ED-HMI3630-133C

PCN

by EDA Technology Co., Ltd

Product Change Notice 1

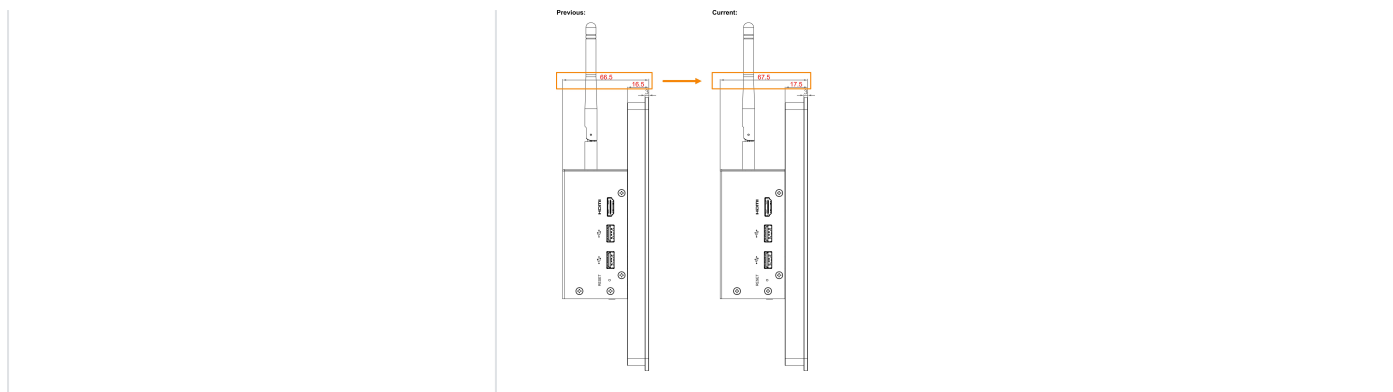
Changes	Results
LCD bezel thickness increased by 1mm	We have optimized the LCD bezel structure to provide additional clearance for internal cable routing. - LCD bezel thickness: adjusted from 16.5mm to 17.5mm. - Total product thickness: correspondingly adjusted from 66.5mm to 67.5mm.
